City of Coral Gables Planning Division Staff Recommendation

Applicant:	Califon Company N.V.
Application:	Conditional Use Review for a Building Site Determination, Tentative Plat Review and Zoning Code Amendment
Property:	6801 Granada Boulevard, Coral Gables, Florida
City Public Hearing Dates/Times:	Planning and Zoning Board December 11, 2013, 6:00 – 9:00 p.m. City Commission Chambers, City Hall, 405 Biltmore Way, Coral Gables, Florida, 33134

SITE PLAN / FIRST FLOOR PLAN

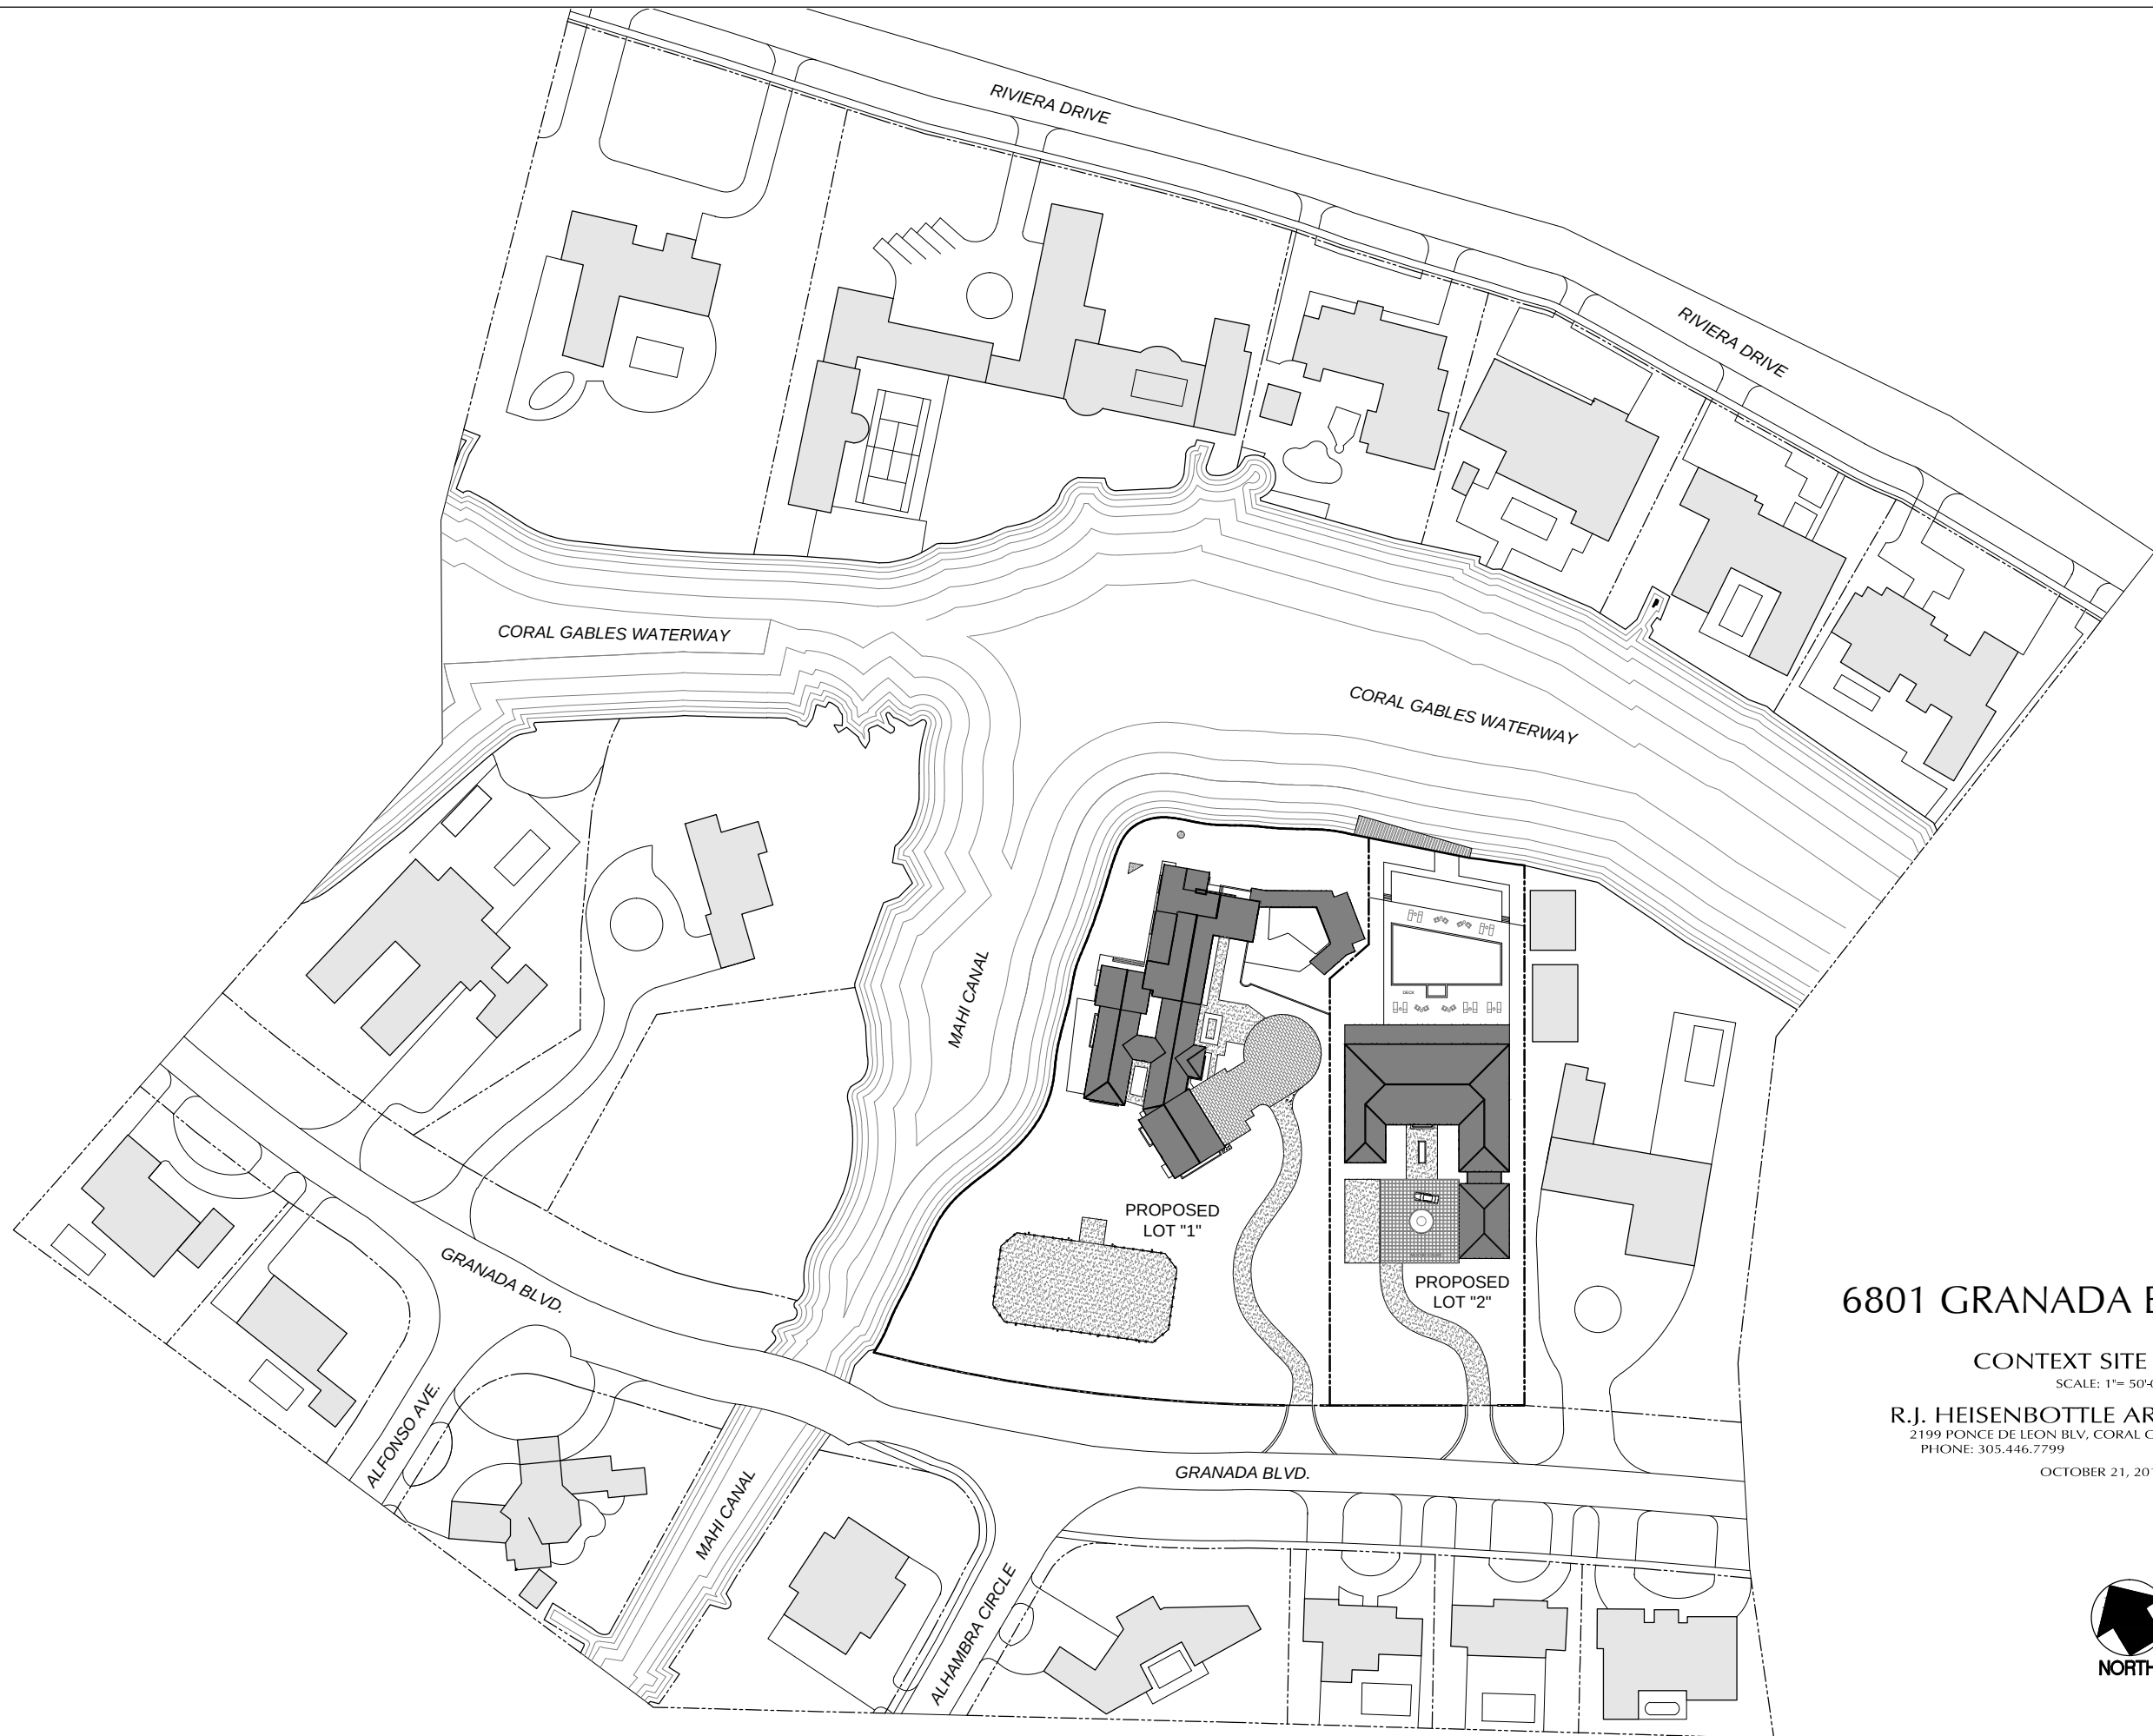
2. PROVIDE HEIGHT OF CBS WALL SURROUNDING POOL AREA.

4. PROVIDE DISTANCE FROM POOL TO SIDE PROPERTY LINE.

RESPONSE: The existing 3'-6" CBS wall surrounding the pool will be raised to 4'-0" high. See revised Proposed Site Plan.

RESPONSE: See dimension from pool to property line on revised Proposed Site Plan.
